REVISIONS		CITY OF RIVERSIDE CALIFORNIA DEPARTMENT OF PUBLIC WORKS
MARK	DATE	
		<b>RECORD OF SURVEY 646 STREET PLAN AND PROFILE OF INDUSTRIAL AVE. - FREMONT ST. TO JASMINE ST.</b>
DESIGNED BY	CHECKED BY	
DRAWN BY	APPROVED BY	<b>R-575</b> SHEET 1 OF 3
RECOMMENDED BY	DATE

REVISIONS		CITY OF RIVERSIDE CALIFORNIA DEPARTMENT OF PUBLIC WORKS
NO.	DESCRIPTION	
		RECORD OF SURVEY 646 STREET PLANS AND PROFILES - GRIFFITH ST. AND REPUBLIC ST. INDUSTRIAL AVE SLY

RECORD OF SURVEY 646  
 STREET PLANS AND  
 PROFILES ORDWAY ST.  
 AND JASMINE ST. FROM  
 INDUSTRIAL AVE. SLY

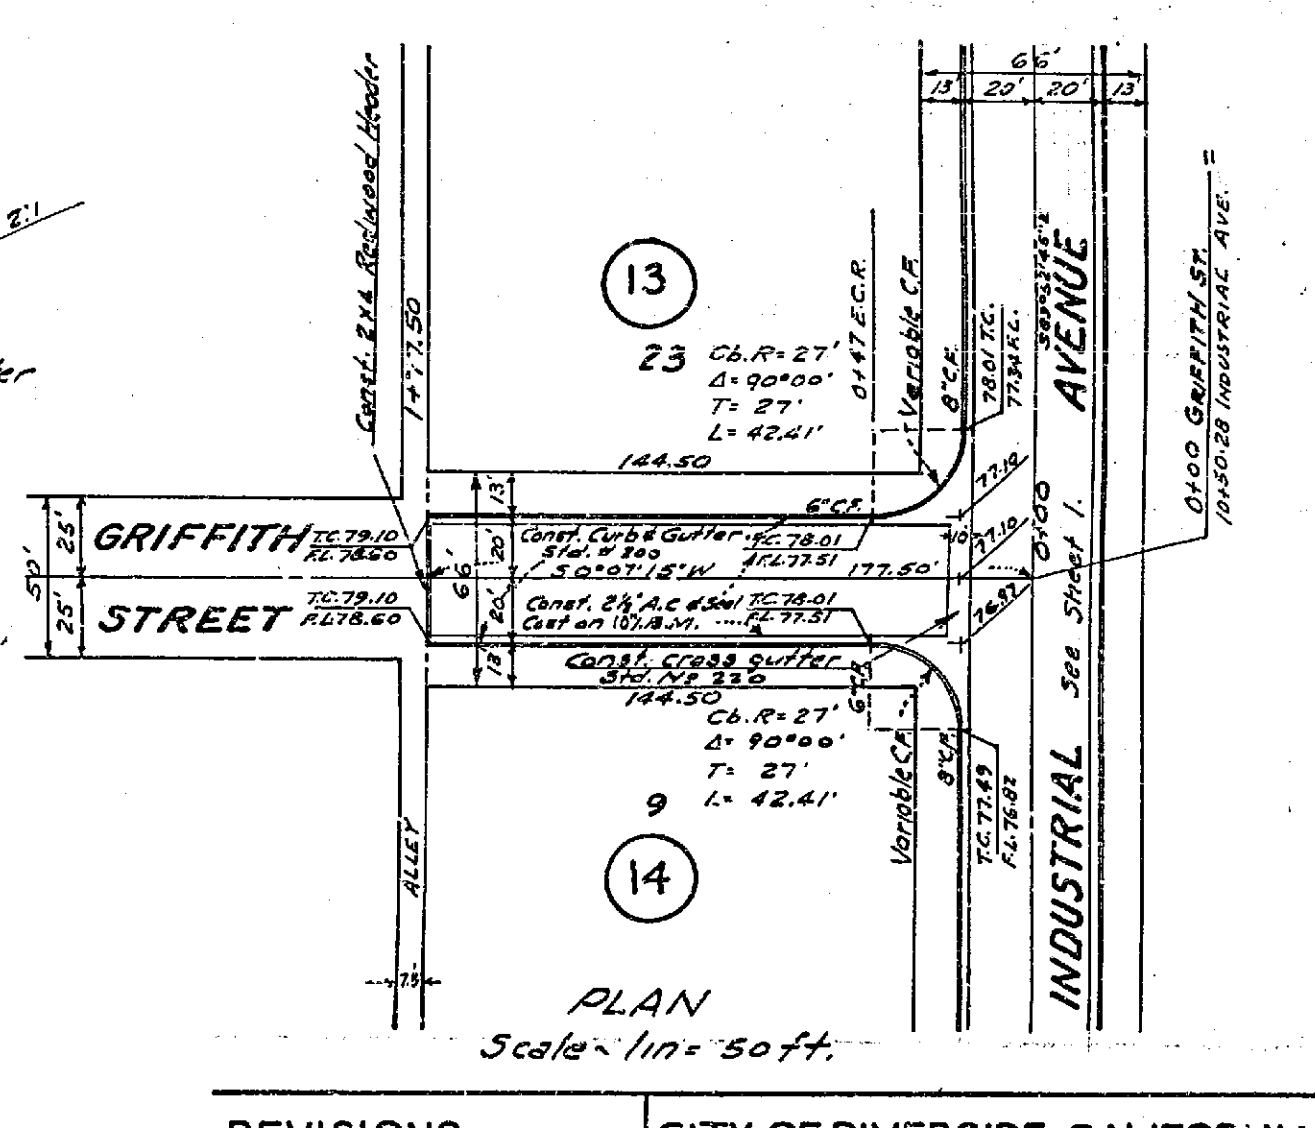
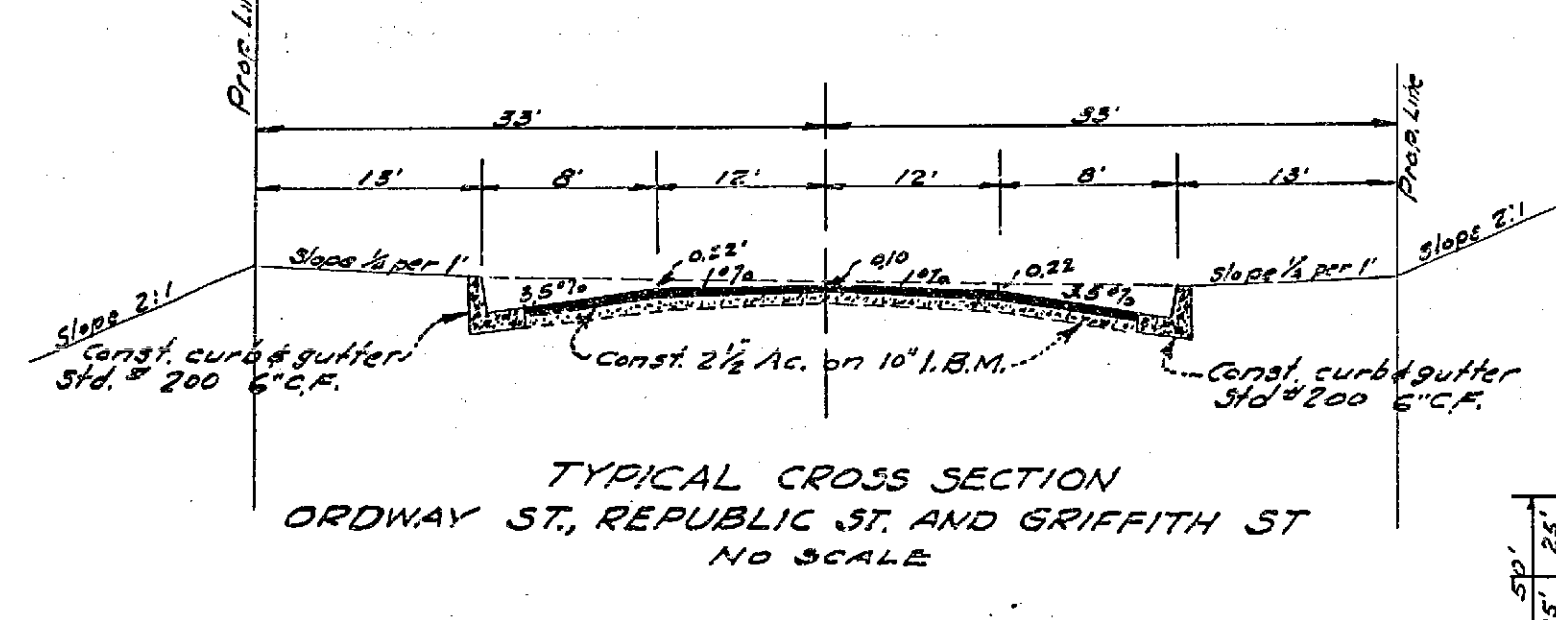
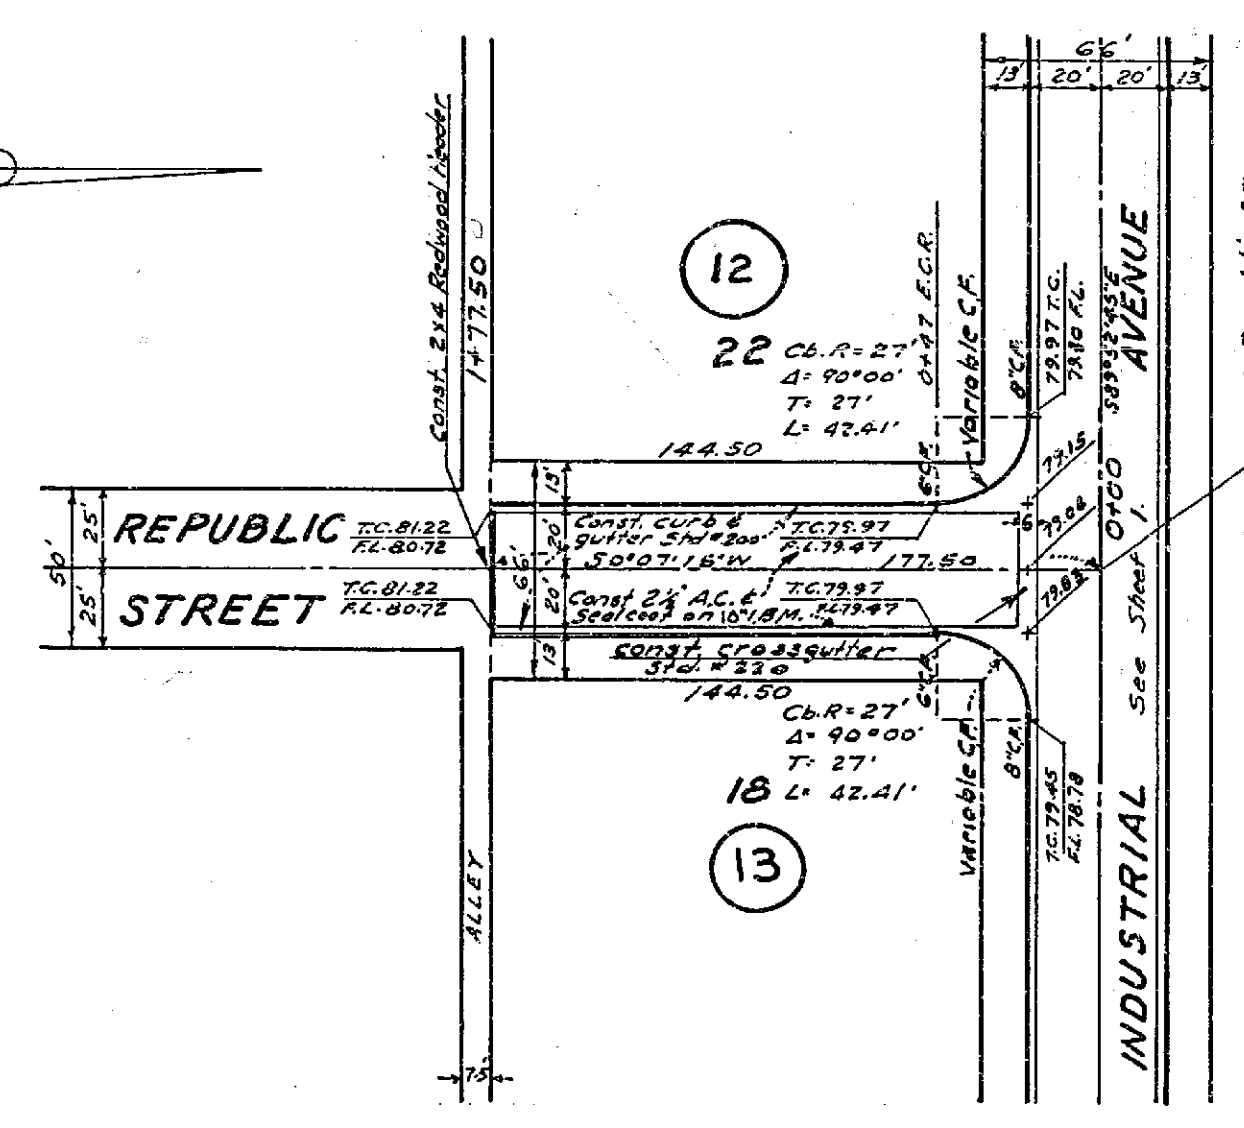
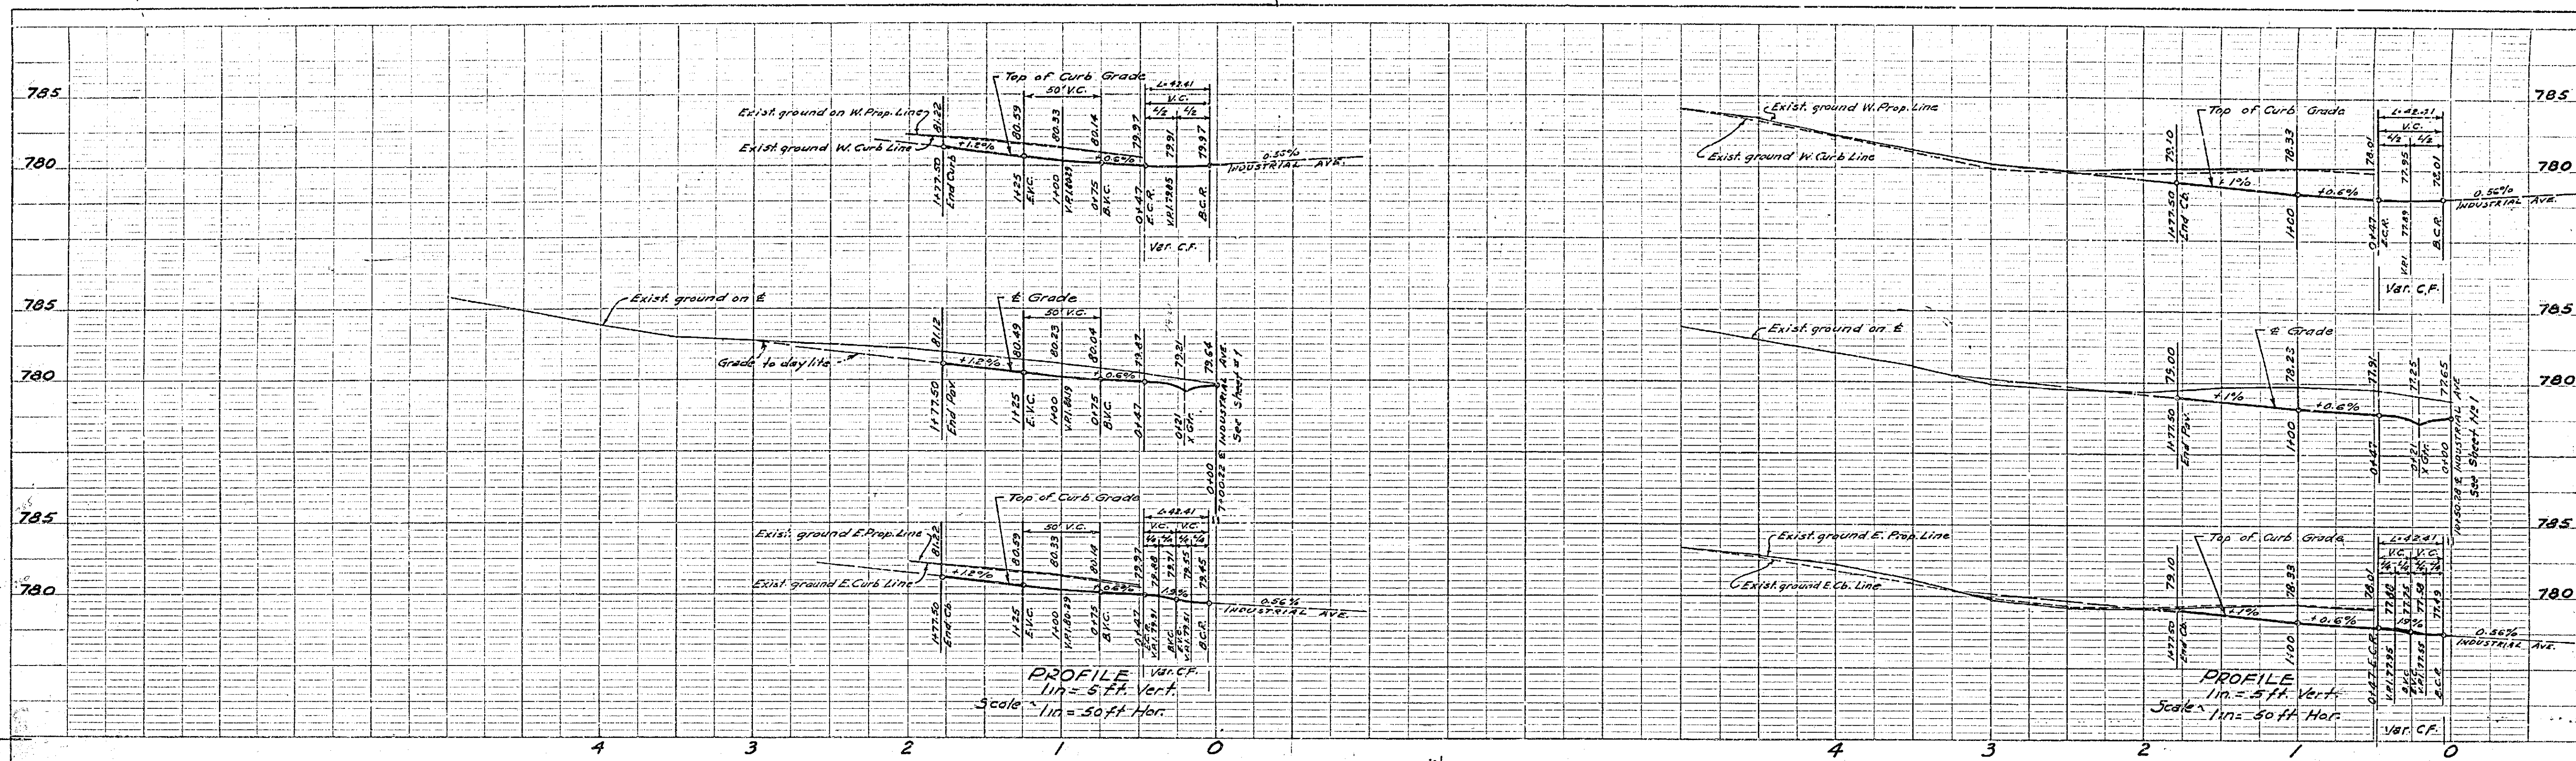
Revision No 1  
Plan R-575 revised by  
grade change 3/11/42 & 6/15  
added bumpouts at Jasmine St. JWA  
George O. Crawley  
Date: 4/16/42 R-575

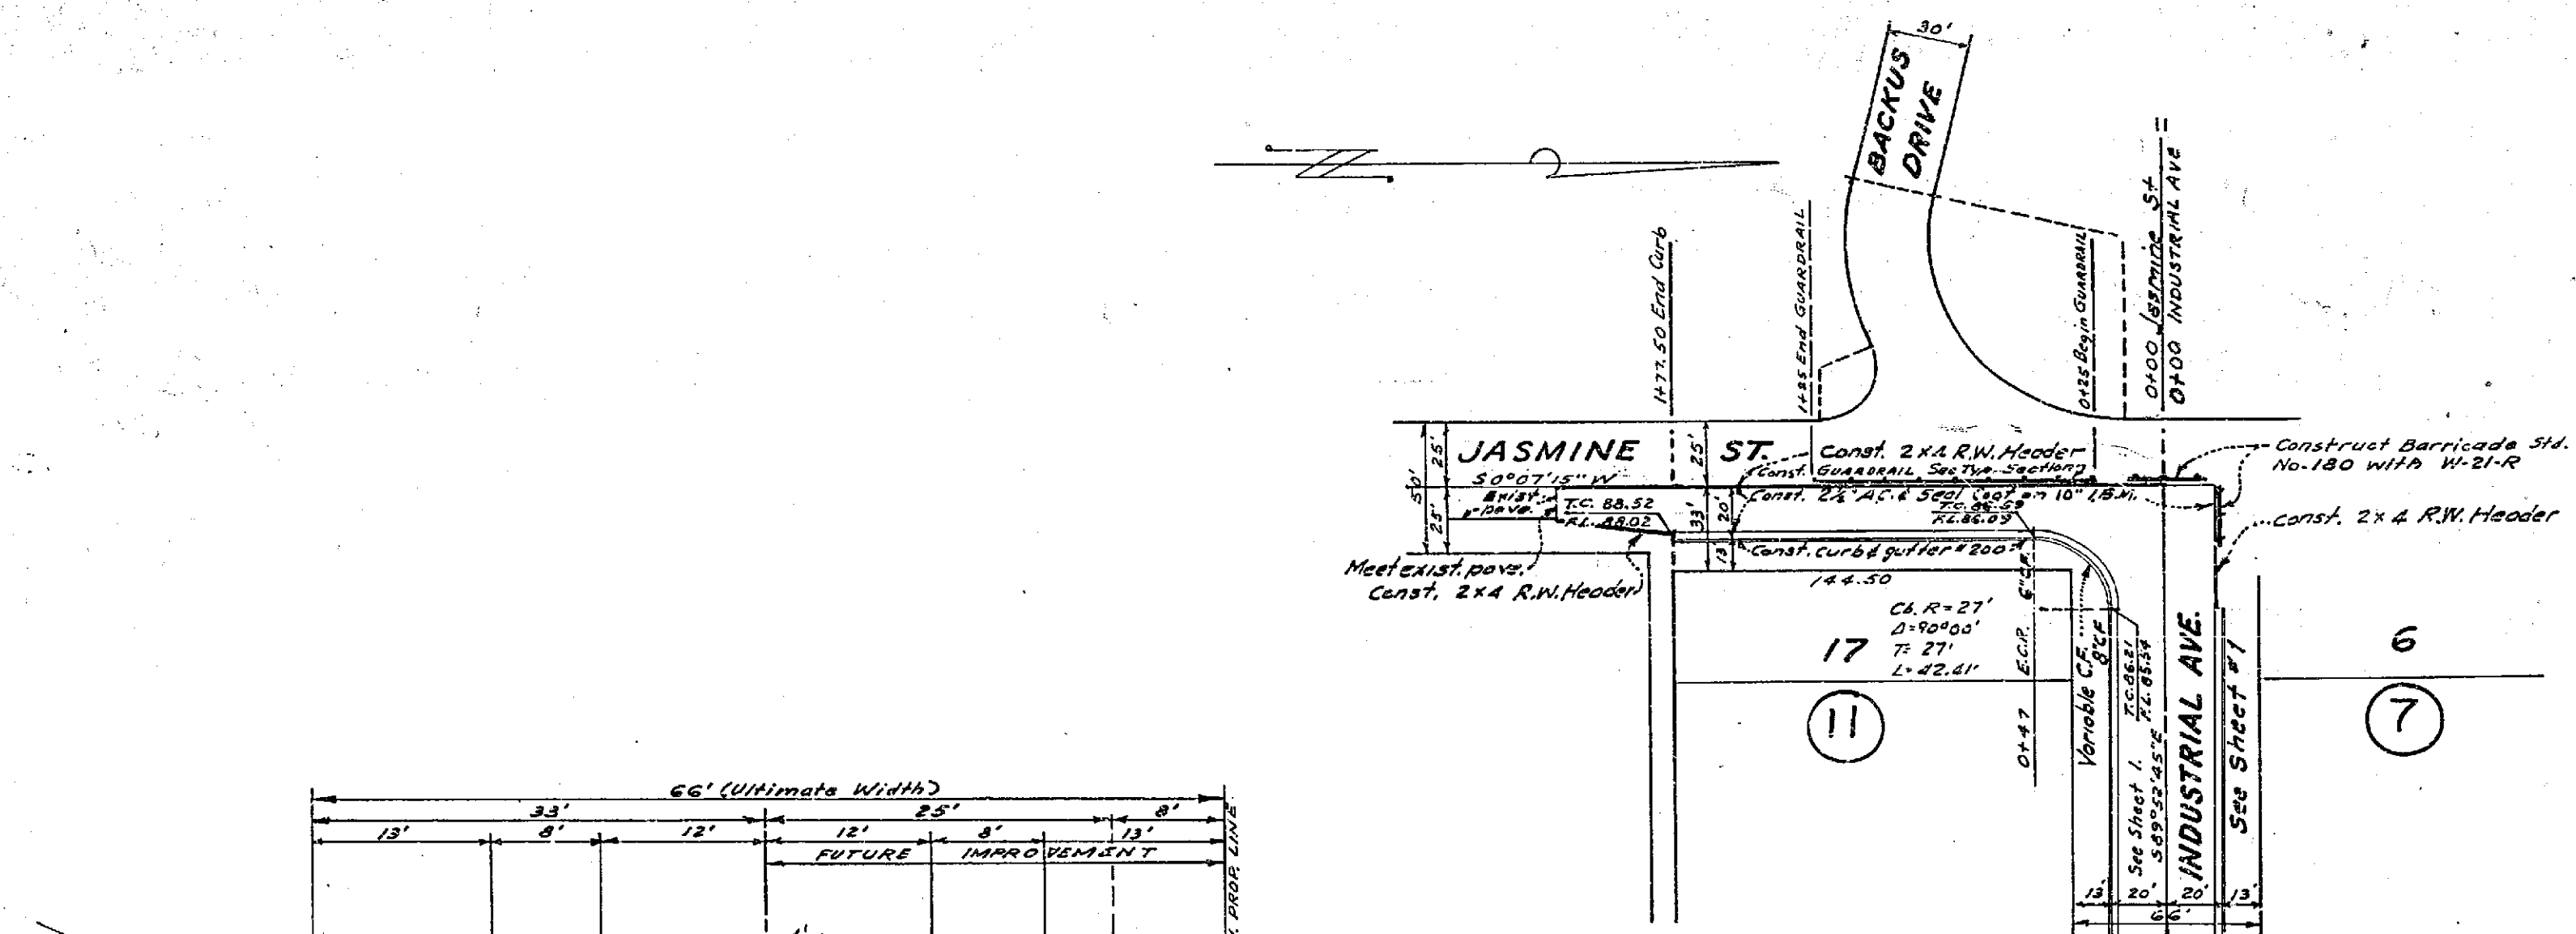
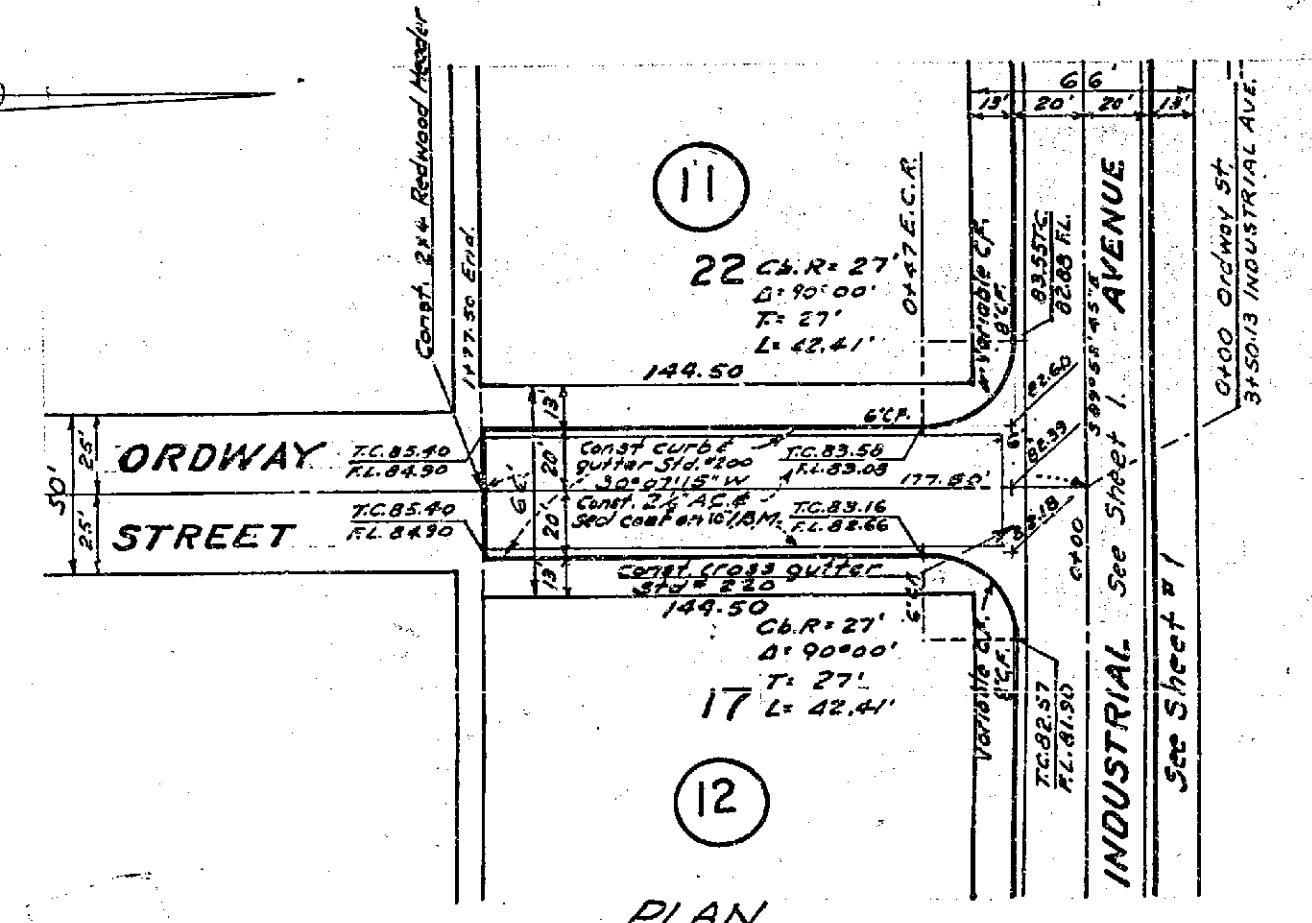
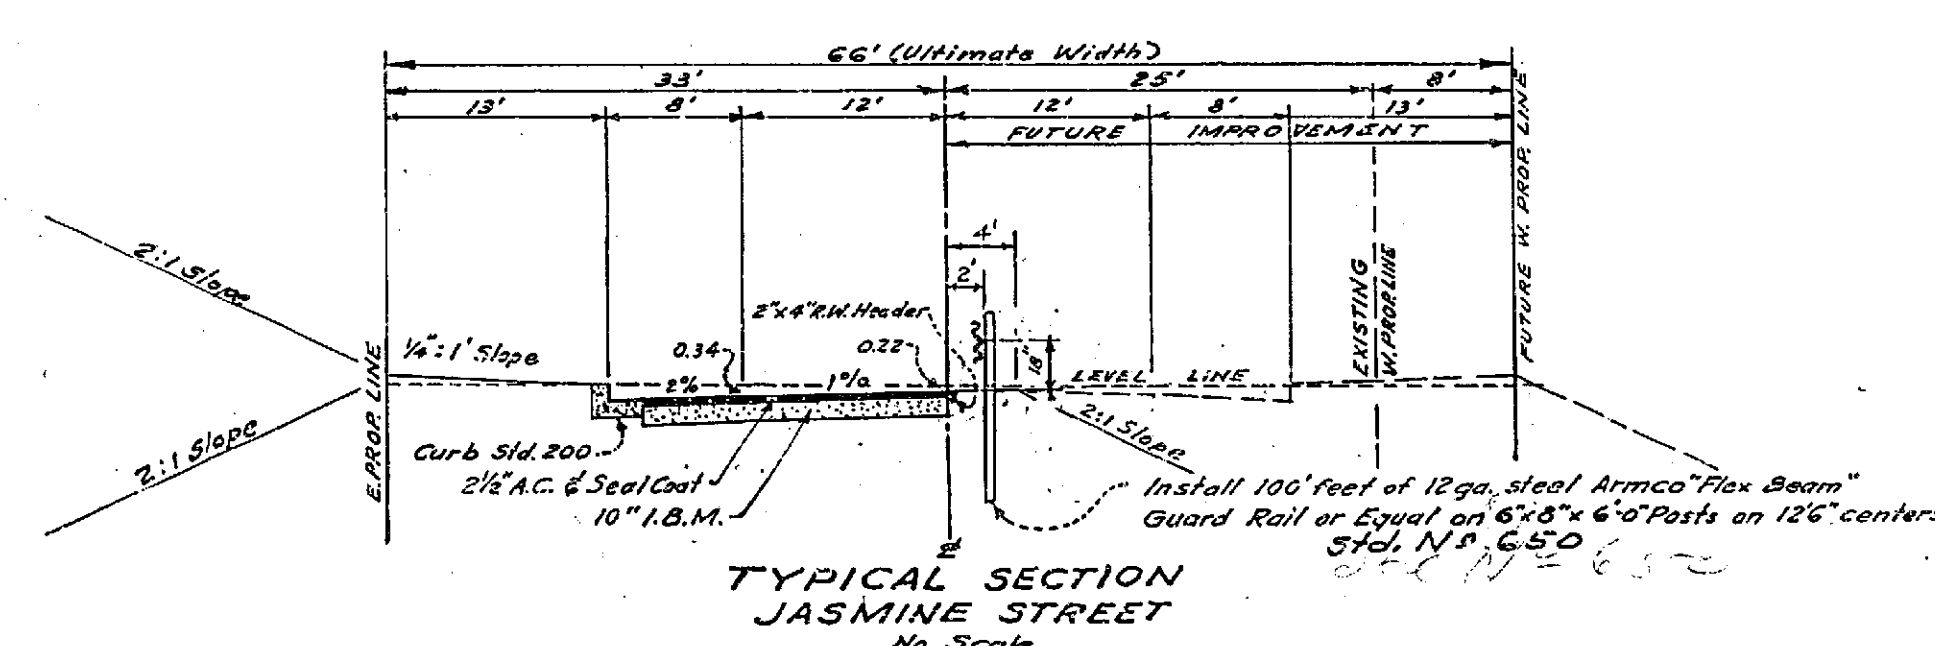
5-8-62 See Note at 1077.

Revision NPI  
 Plan R-575 revised by grade change  
 0150 to 1177.50 on Ordway St & Jasmine St and  
 Jasmine cross section.  
 George O. Crawley  
 Date 5-8-62. R.C. 2453 Approved.  
**McKee & Crawley**  
 SURVEYORS AND ENGINEERS  
 Riverside California  
 Approved George O. Crawley P.E. 9485 Date 2-7-62
